CITY OF ST. HELENS PLANNING DEPARTMENT
STAFF REPORT
Variance V.4.21
Accessory Structure AS.4.21

DATE: December 7, 2021
TO: Planning Commission
FROM: Jennifer Dimsho, AICP, Associate Planner

ZONING: Moderate Residential (R7)
LOCATION: 2705 Columbia Blvd; 4N1W-5DC-1400
PROPOSAL: Variance to construct a 1,728 sq. ft detached accessory structure which is larger than the allowed maximum size

City Wetland Inventory Except

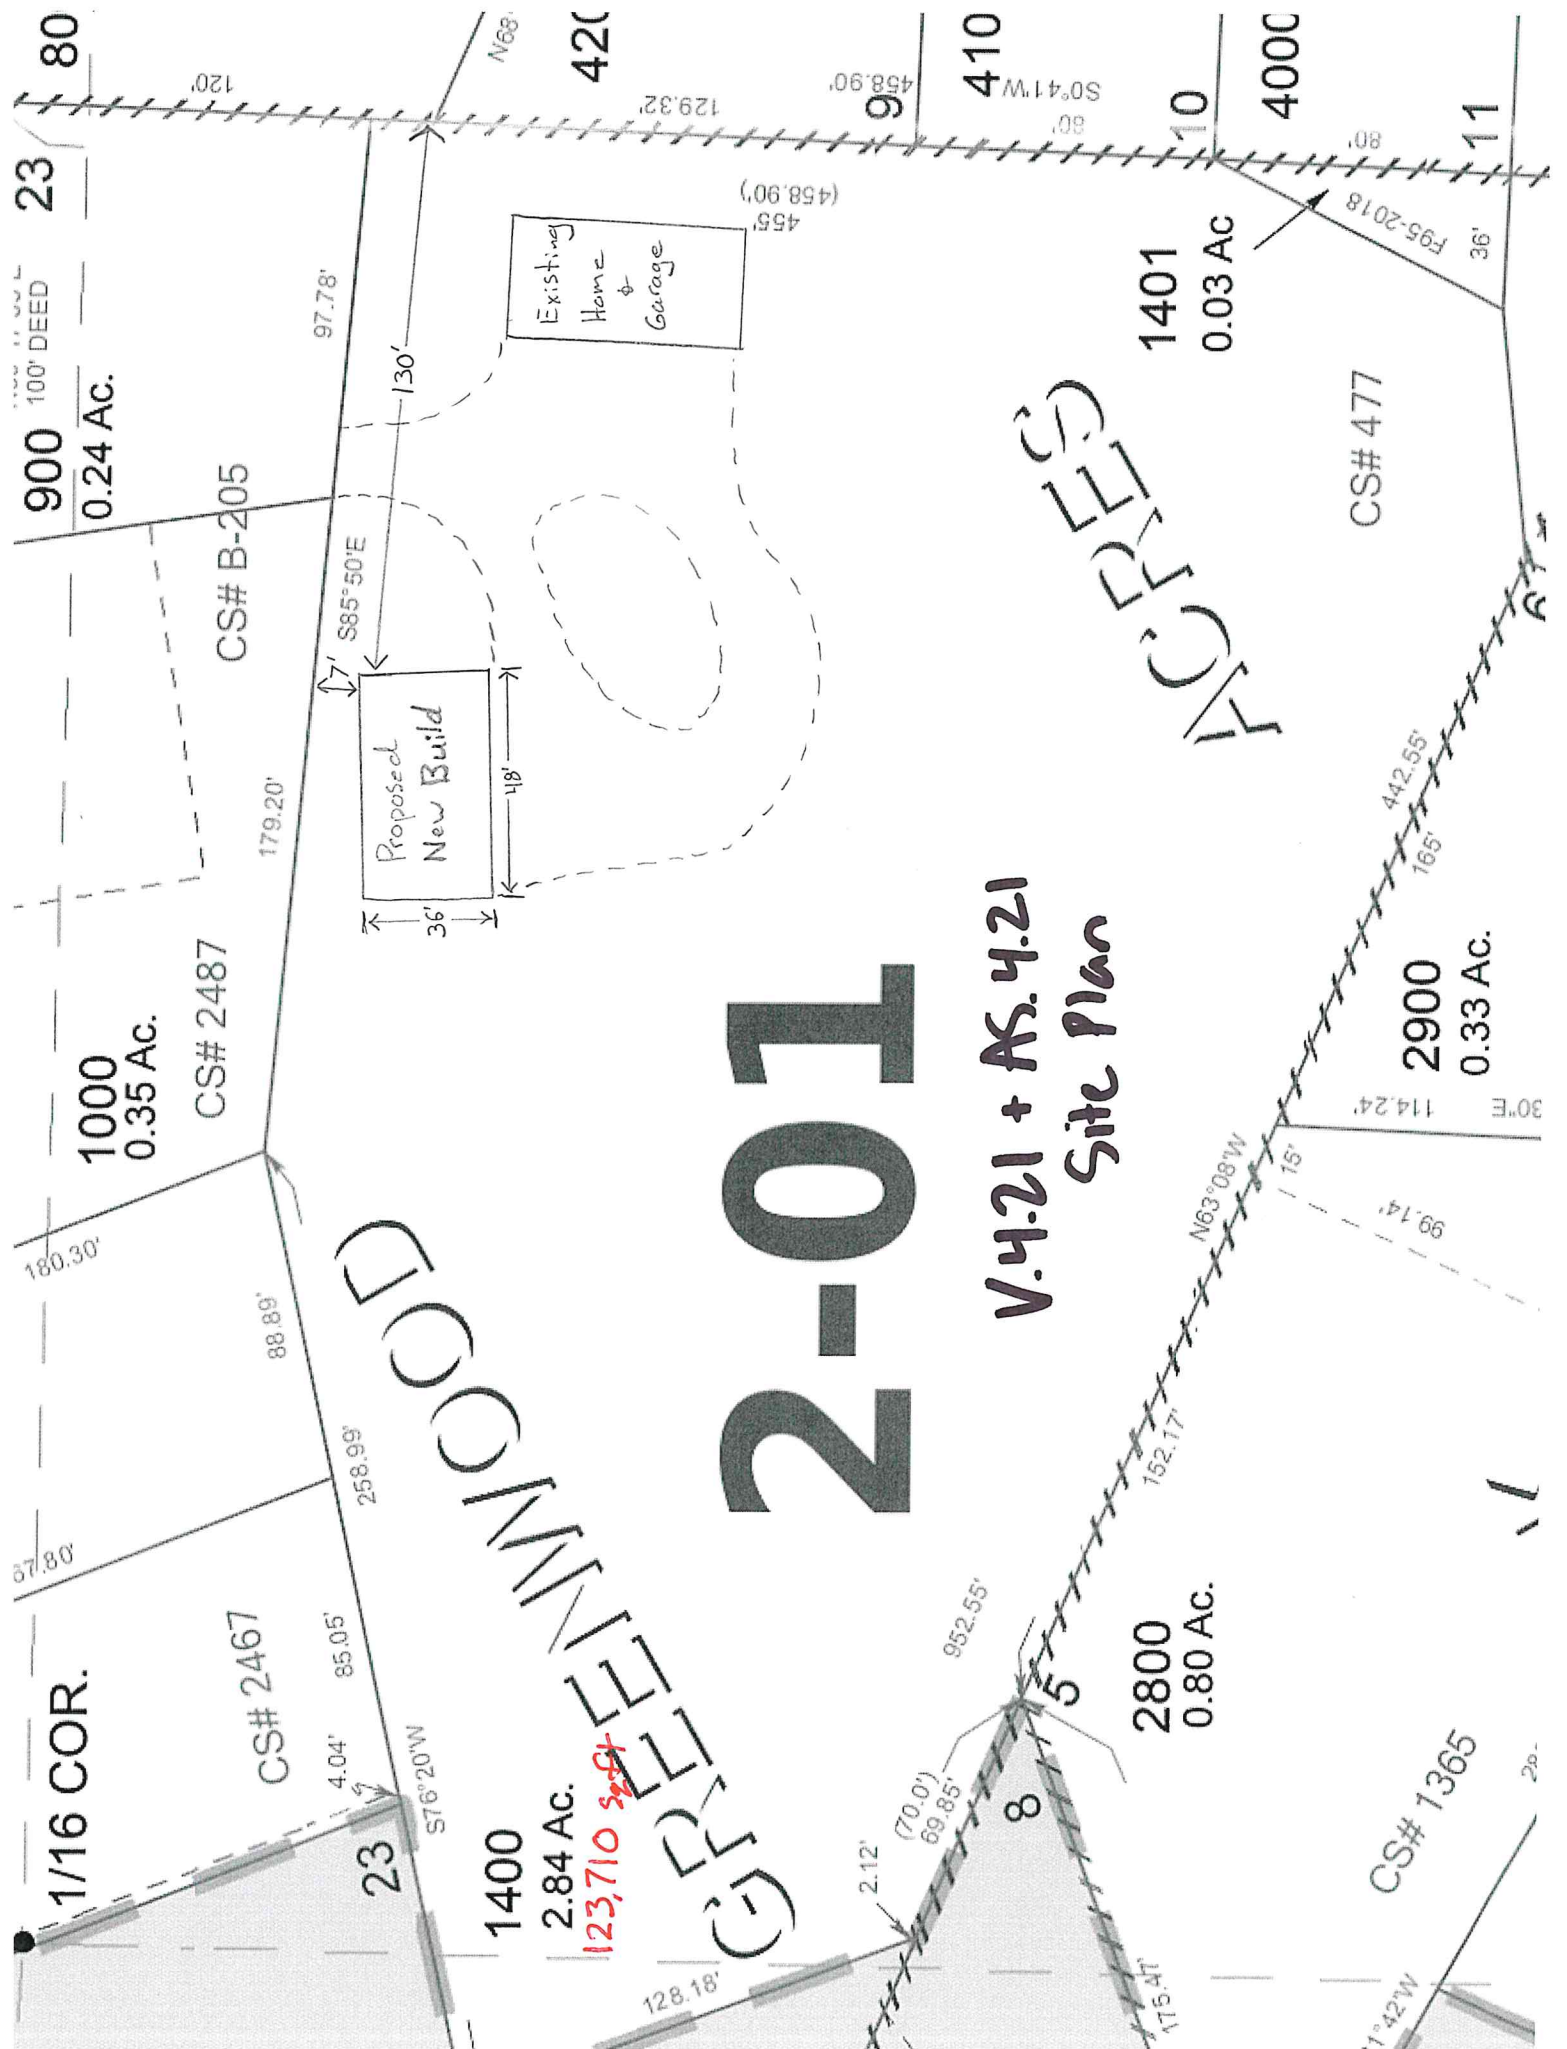
Sensitive Lands: Per the City's wetland inventory, the majority of the site is encompassed by wetland MC-21, which is a Type II wetland per Chapter 17.40 SHMC and includes a 50' upland protection zone. No environmental assessment (per Chapter 17.40 SHMC) or wetland delineation with the Oregon Division of State Lands has been conducted; the information the city has is not field verified for accuracy as it is only based on the wetland inventory conducted in the 1990s. Rules protecting certain wetlands and establishing upland protection zones took affect in December 2003. As the site was developed long before this date, some grandfathered circumstances are probable.

Staff inspected the site in late November. The gravel circular driveway is likely grandfathered (if within protection zone) and the area proposed for the accessory structure is assumed to be at least partially grandfathered regarding ground cover vegetation maintenance. The code allows the director to waive an Environmental Assessment (determination of wetland boundaries by a qualified professional) in certain circumstances. In this case, the site is very flat, and staff cannot fairly conclude where wetland boundaries are. The applicant's desire to have the building and access improvements to it, are westerly enough that the provisions of Chapter 17.40 SHMC cannot be overlooked.

1. Allow the accessory structure in the location proposed only after an Environmental Assessment is conducted and any applicable Sensitive Lands Permitting is applied for and approved with all requirements thereof met; **or**

2. Allow the accessory structure and related improvements (e.g., drive surface) in an alternate location that is undisputedly outside of any wetland or protection zone boundary (e.g., along the east property line south of the existing dwelling).

V.4.21 + A.4.21
Site Plan

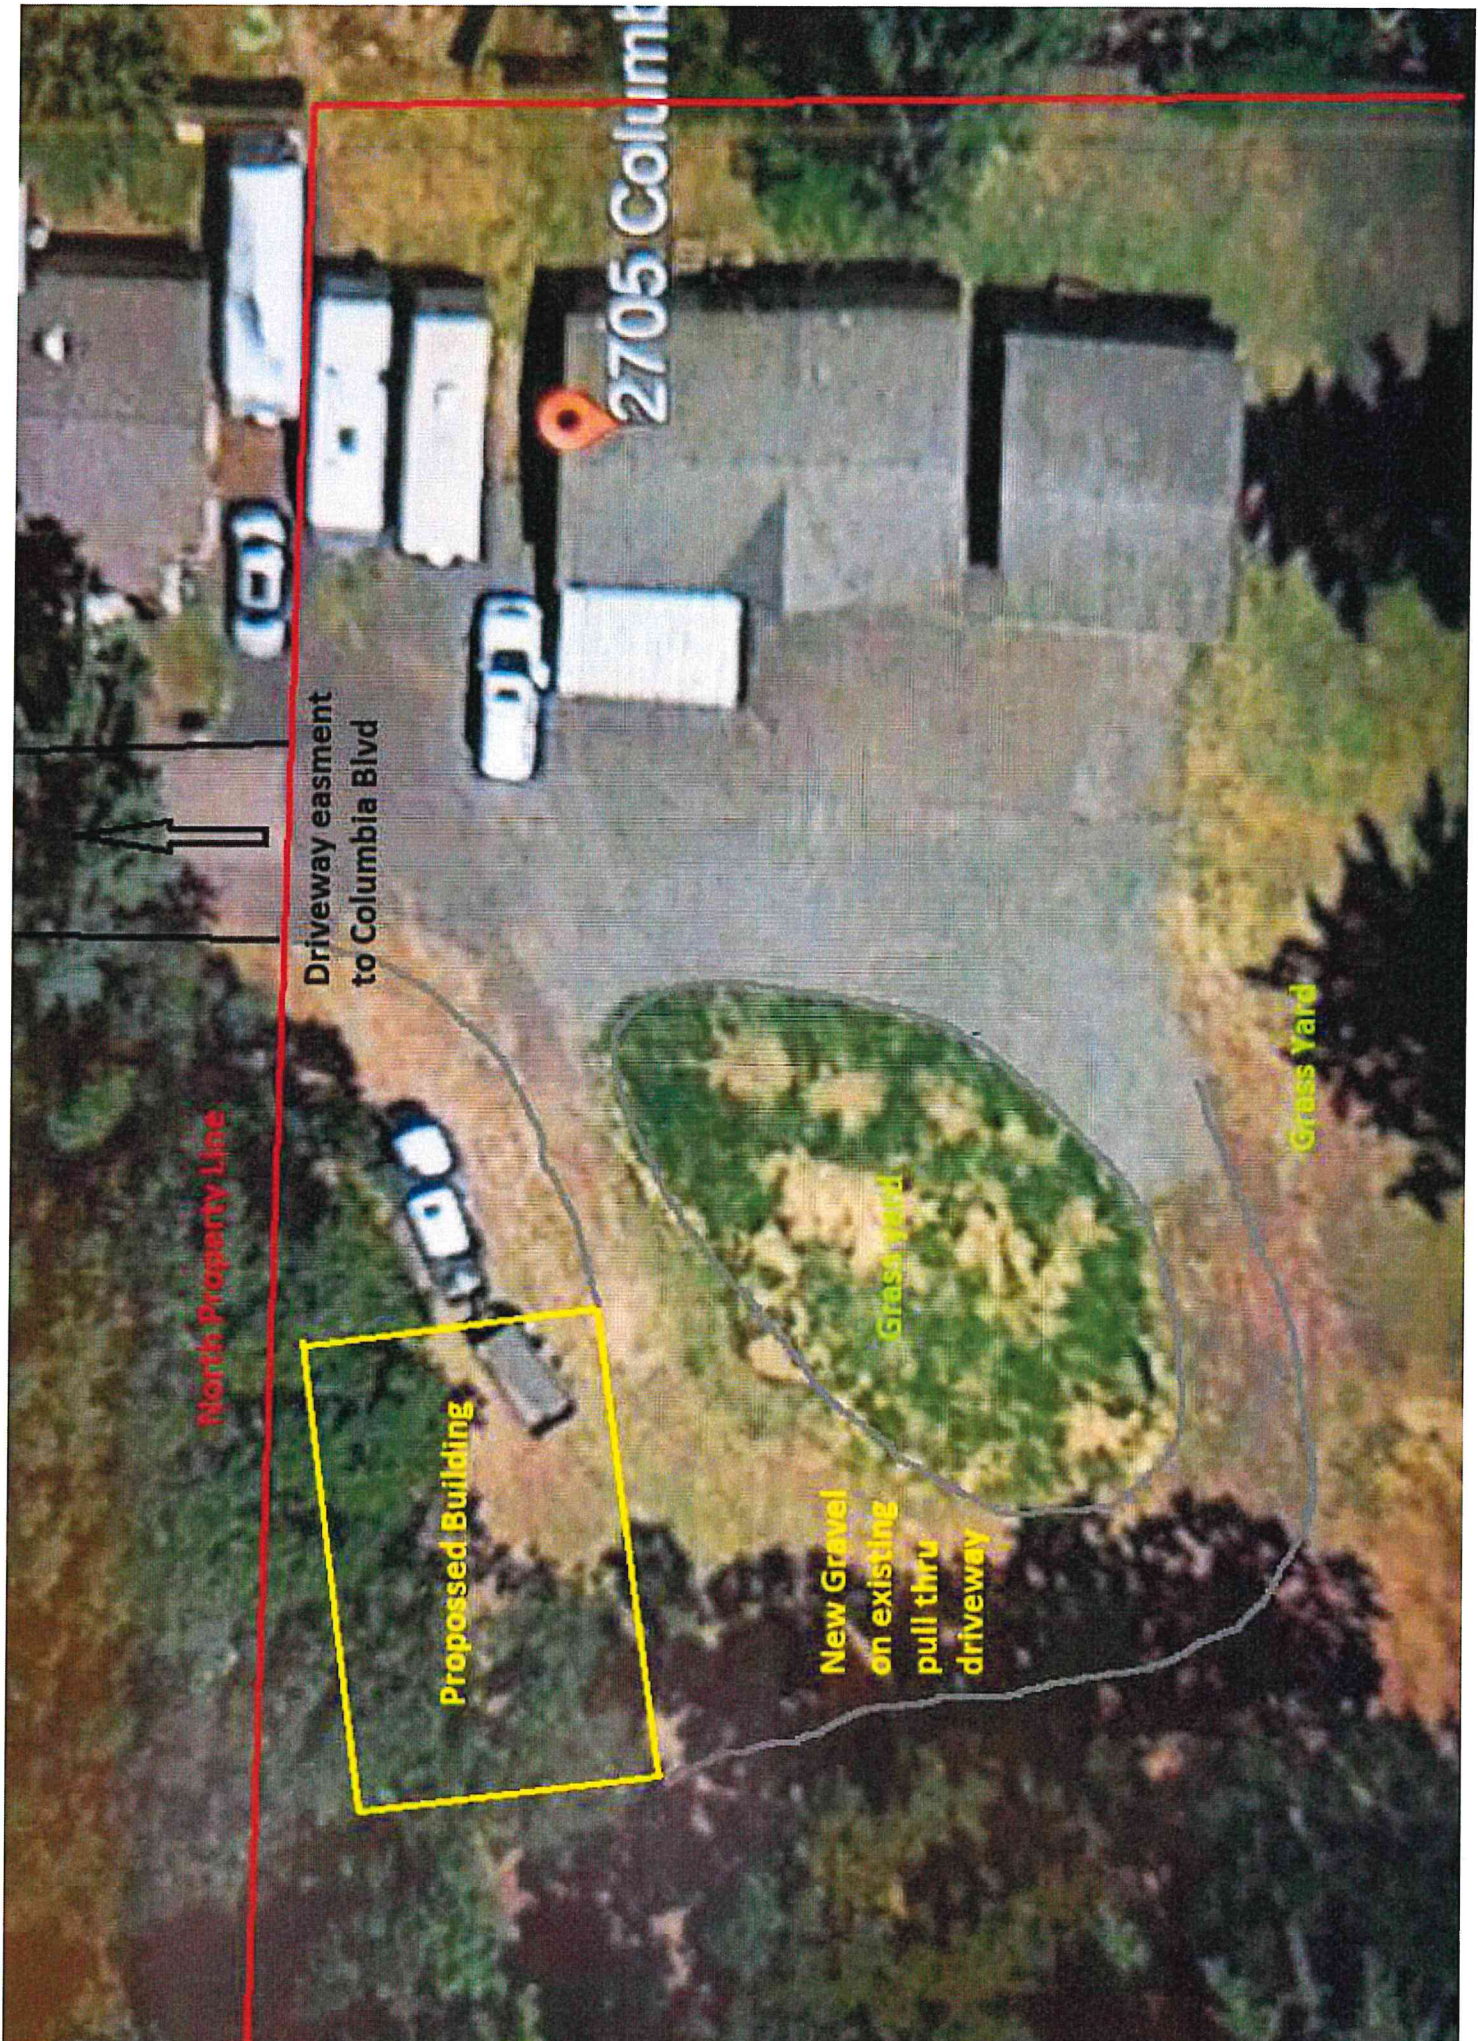
Maximum size allowed: Maximum *gross floor area* (GFA) allowed for an accessory structure in a residential zone depends on property size. The maximum GFA is 1,000 sq. ft. for properties greater than 2.5 acres in size. The property is 2.84 acres and the proposed accessory structure has a GFA of approximately 1,728 square feet. This is the reason for the Variance, which is discussed further later.

The site is accessed via a 20' wide shared private easement that serves about 5 separate properties (including the subject property), each developed with a detached single-family dwelling. This shared drive is as narrow as 10' and predominately gravel, though partially paved at opposing ends. Under this scenario if under current standards, the minimum access easement would need to be 24' wide and at least 20' wide paved driveway. However, this is a grandfathered situation, and not a land division, which would create new parcels entitled to be developed (and be difficult to approve).

Because this is a residential area, technically, gravel is not allowed as a drivable surface. See discussion/findings under 17.108.050(1)(a) below.

1. A minimum paving requirement of the width of the shared drive 25 feet back from the property line and no gravel allowed within 50 feet of any significant wetland or riparian corridor; **or**

Note: This minimum requirement assumes the private drive should be paved as a shared facility and this property should paved 25 feet behind that to help protect the integrity of the shared drive (one basis for paved streets is to prevent damage from gravel).
 2. Require all areas necessary for vehicles within the property that will use the proposed accessory structure for parking and maneuvering to be paved.
